**PLANNING AND ZONING COMMISSION MEETING**

Tuesday, November 9, 2021, at 4:30 PM  
191 5<sup>th</sup> Street West, Ketchum, Idaho

5. ACTION - Recommendation to approve the 380 N 1st Ave Mixed-Use Building Design Review (Application File No. P21-085).

**STAFF REPORT  
KETCHUM PLANNING AND ZONING COMMISSION  
MEETING OF NOVEMBER 9, 2021**

Figure 2: Foundation Plan (Sheet S2.0)

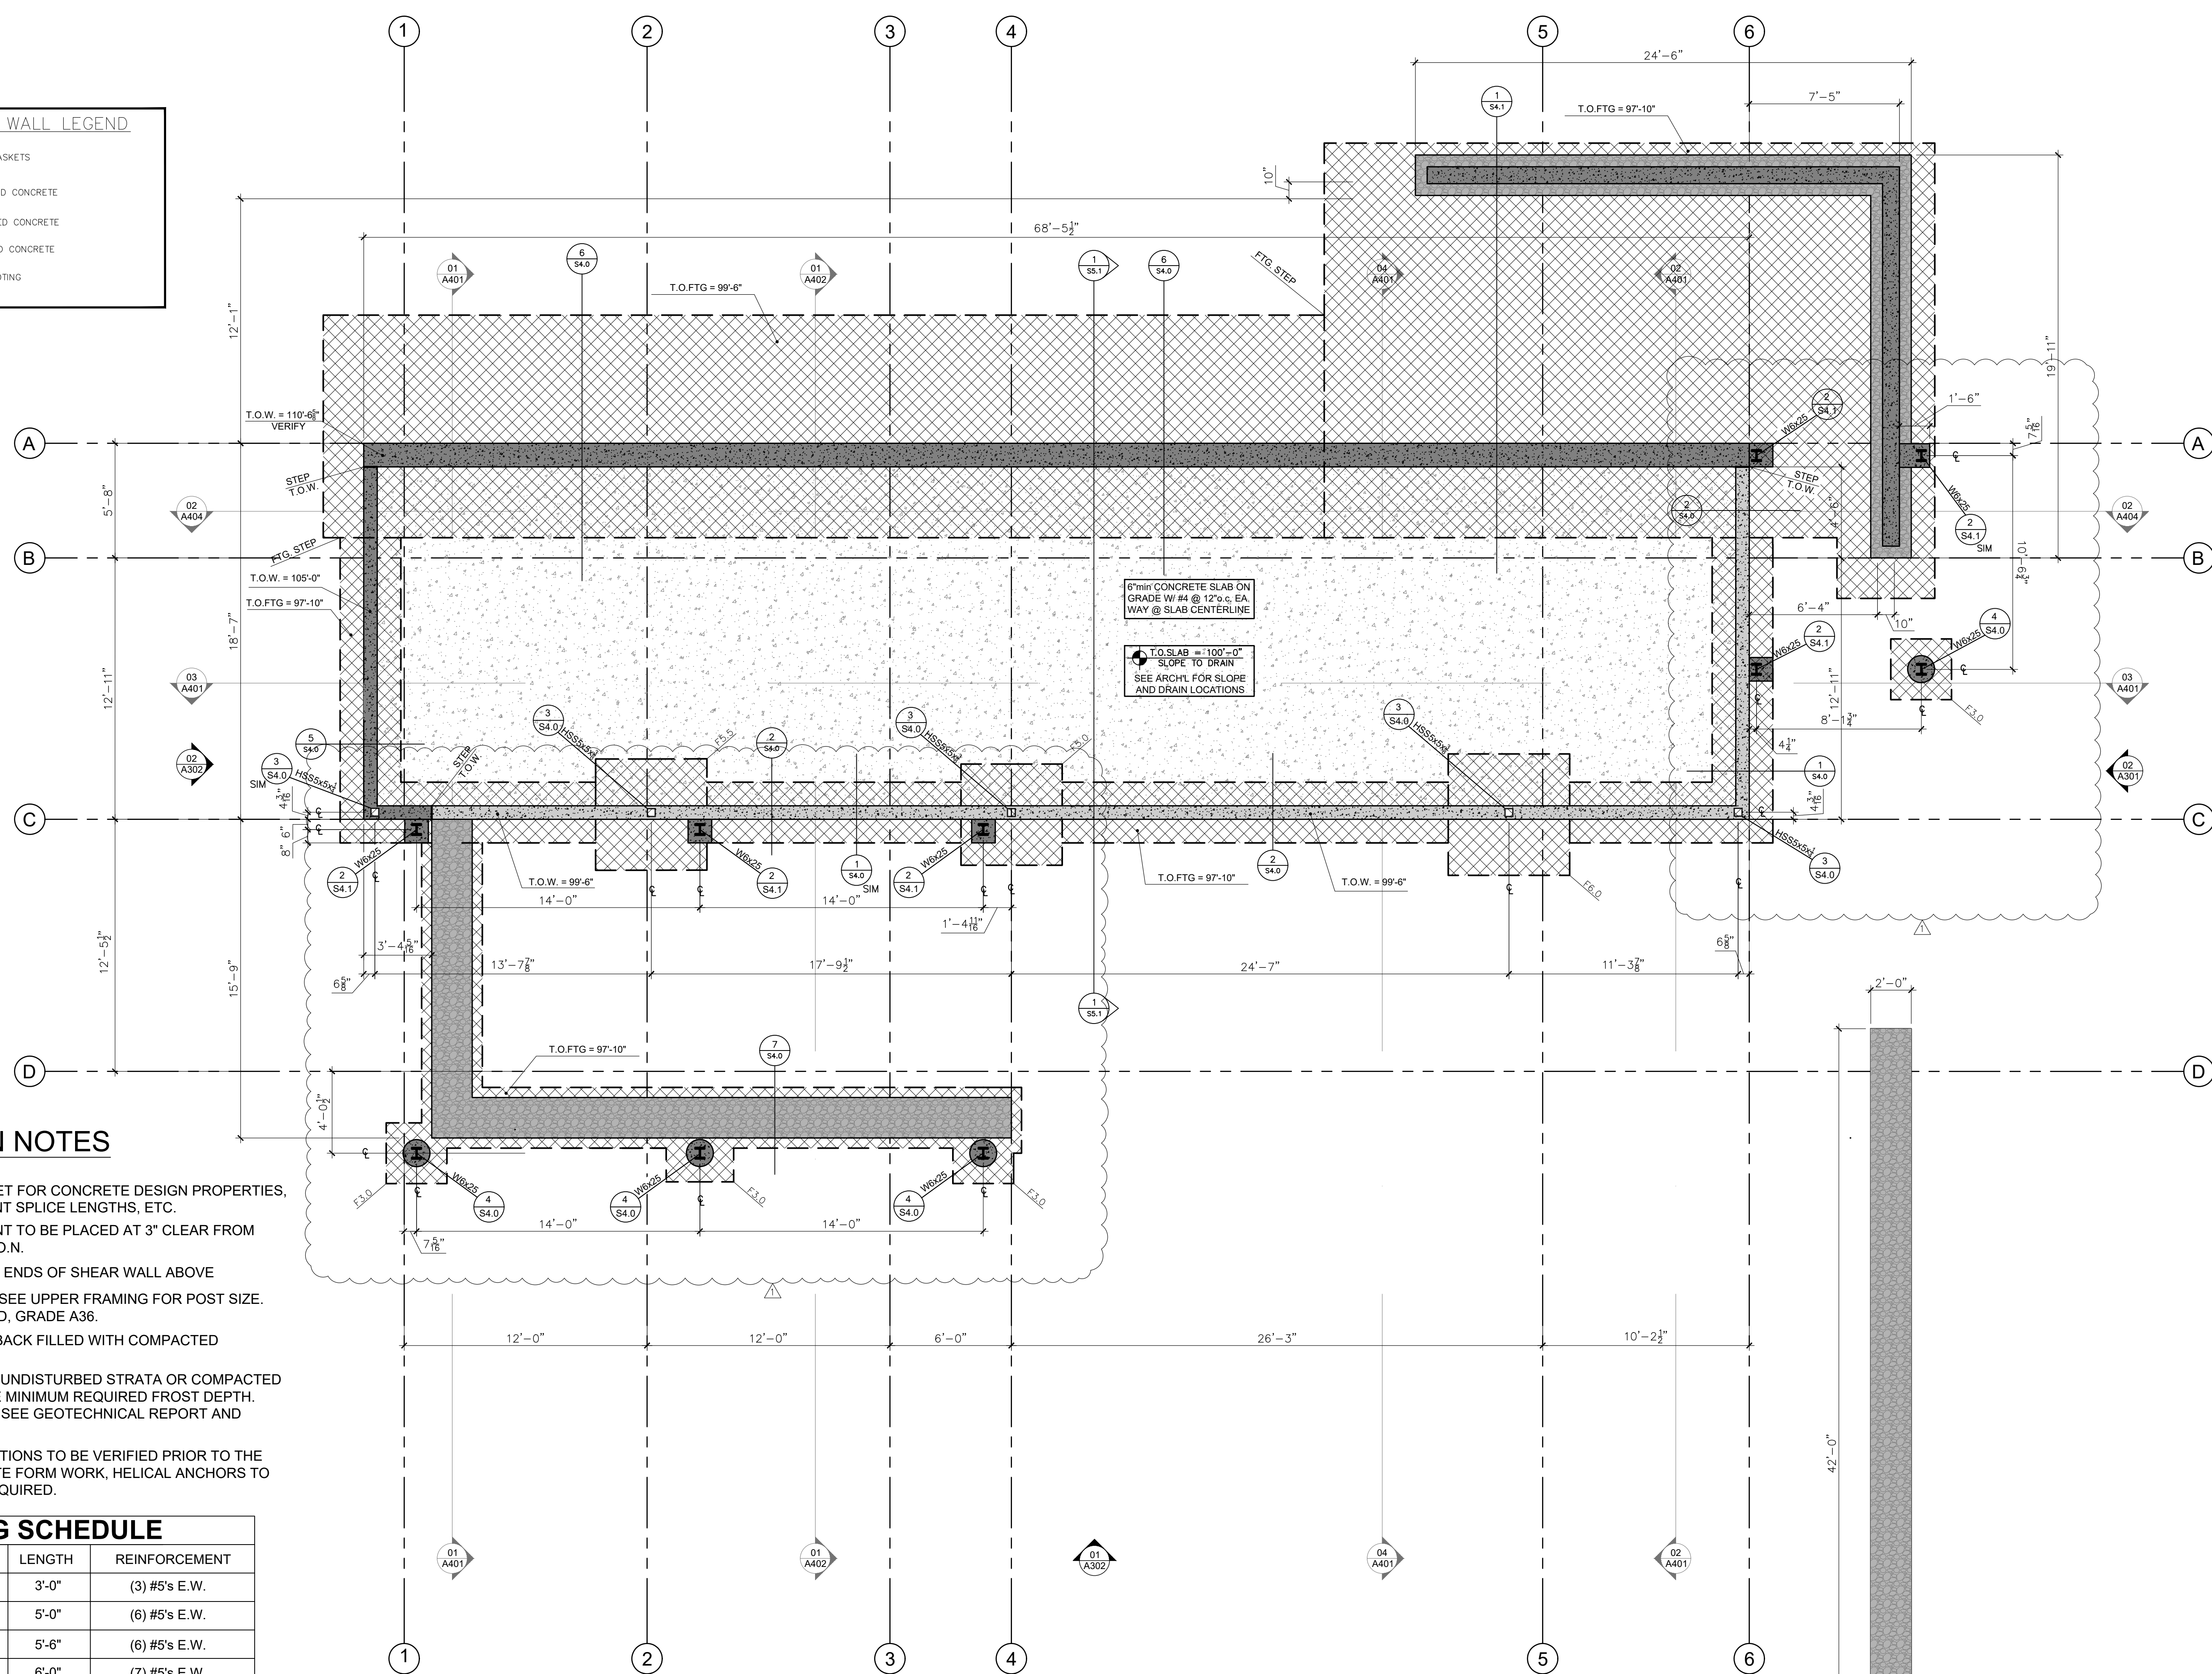
As indicated on Sheet S2.0 (See Figure 2), the home's building footing encroaches into the front setback area. Below-grade structures may encroach into required setbacks subject to the standards specified in Ketchum Municipal Code §17.128.020.K.
